## TUALATIN CITY PLANNING COMMISSION MEETING

THURSDAY, JANUARY 21, 2021

1. The Tualatin Planning Commission is asked to provide a recommendation to the City Council on adopting an updated Stormwater Master Plan for the City of Tualatin and updating Comprehensive Plan policies and relevant Development Code references to reflect the updated plan (Plan Text Amendment PTA 21-0001).

Exhibit 5 – Public Comments on Stormwater Master Plan 12-7-20 through 1-10-21

**Figure 2-4**  
**Land Use**

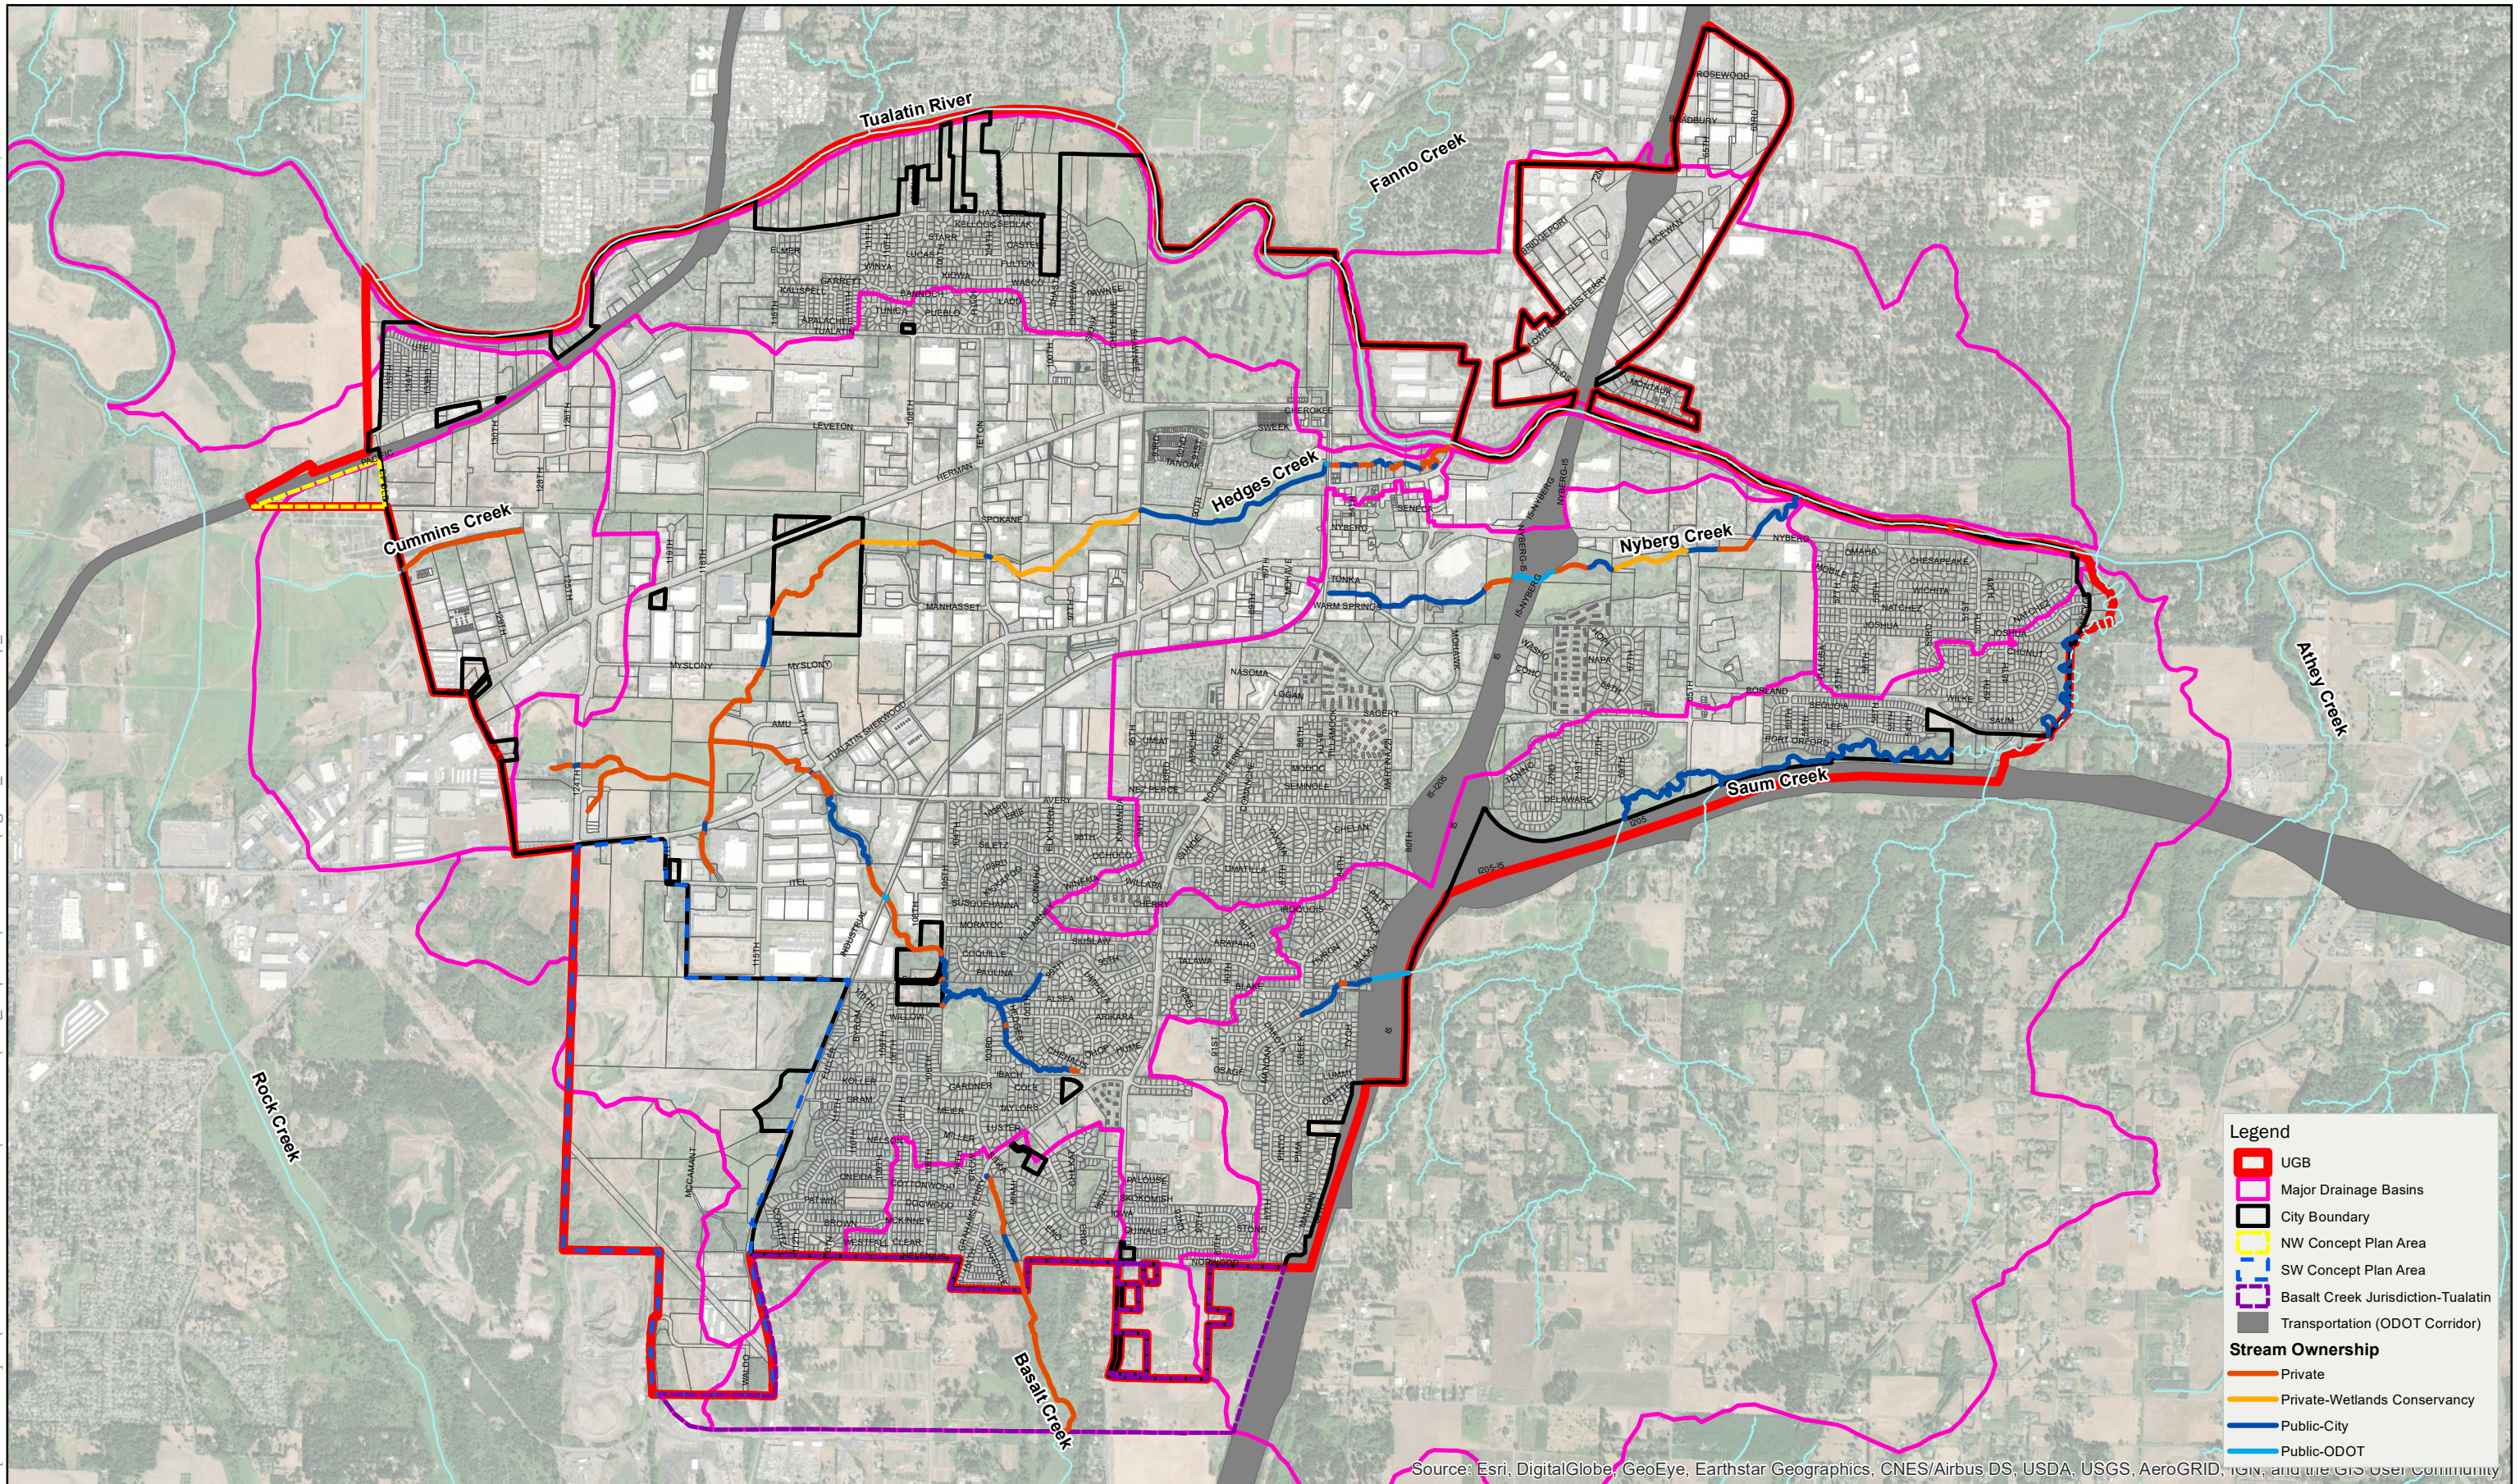
**Figure 2-4 "Land Use" Map Not Consistent with City's Current Land Use Zoning**

**Figure 2-5**  
**Stream Ownership**

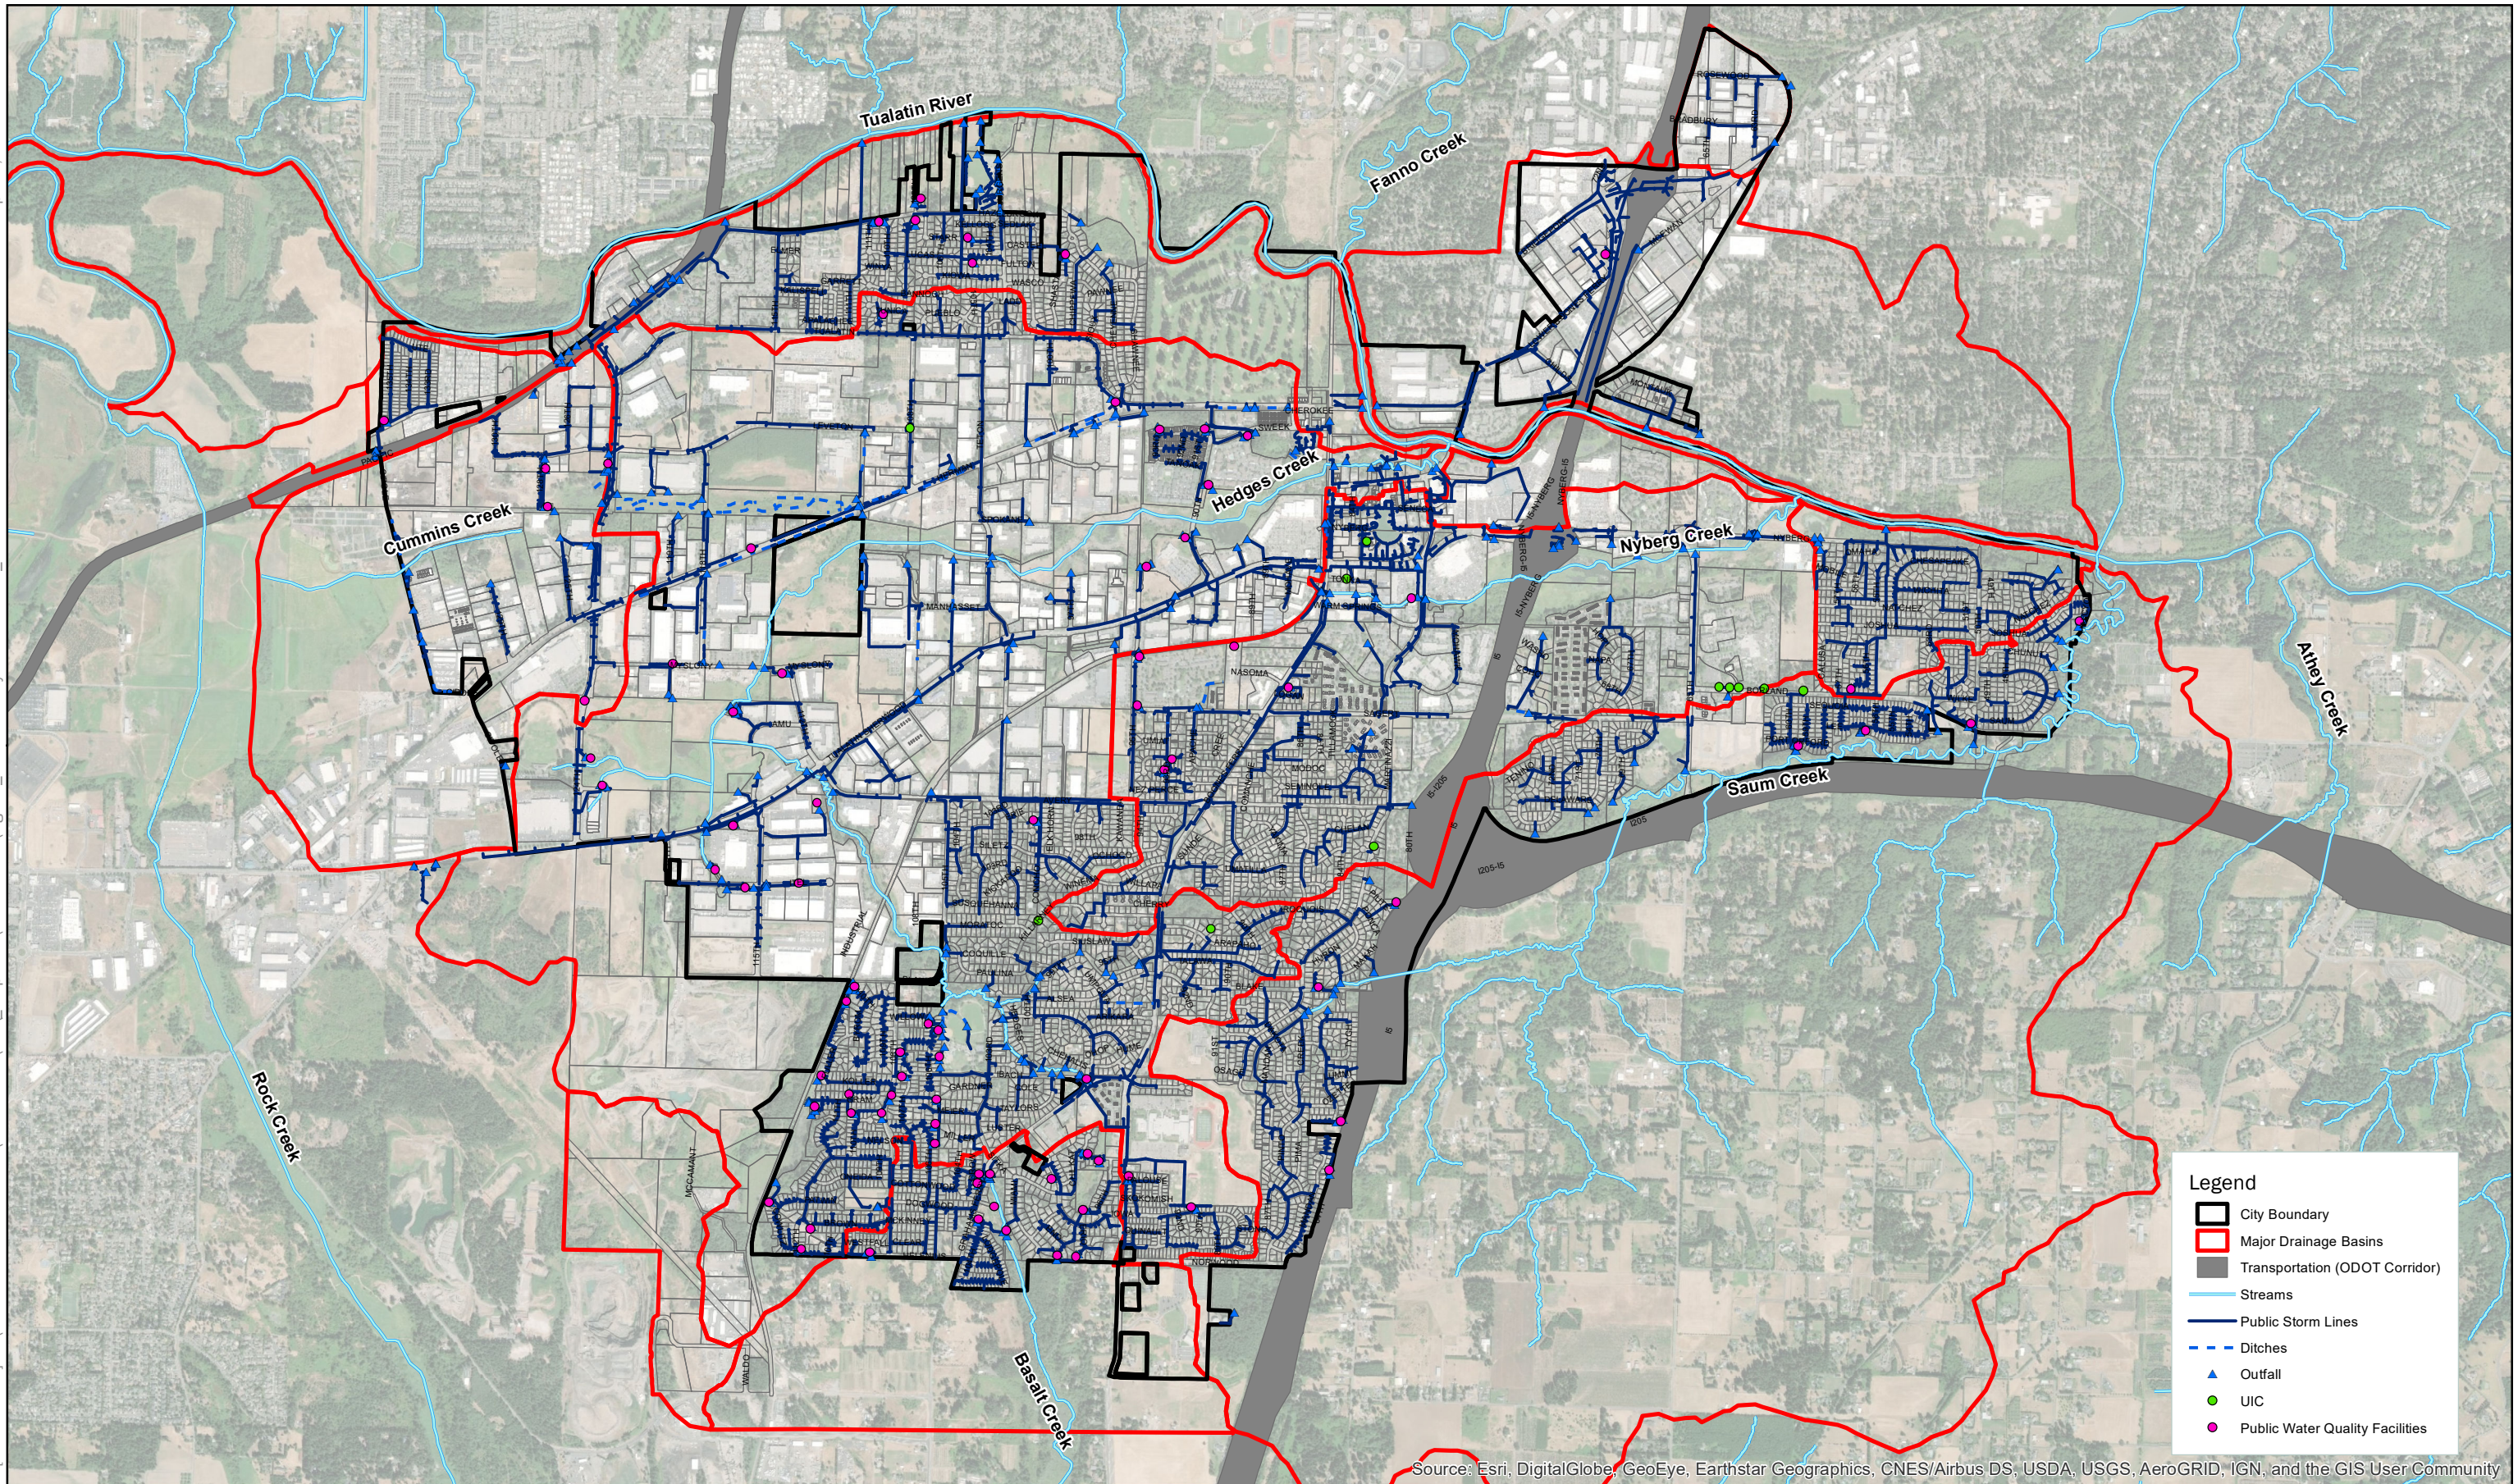
Comment LEA6. The Tualatin SWMP does not include any wetlands in BFR south although they do exist. The SWMP Figure 2-5 - Stream Ownership omits the majority of stormwater impacted wetlands in Tualatin. Metro’s Title 13 – Nature in Neighborhoods is intended to protect natural resources in urban areas but none of these opportunities are identified in the Plan for BFR south. The SWMP calls for protecting natural resources in subsections 1.1 Stormwater Master Plan Objectives and 2.2 Future Planning Areas. None of these opportunities are evaluated in the Plan for BFR south especially for the Basalt Creek Concept Plan area.
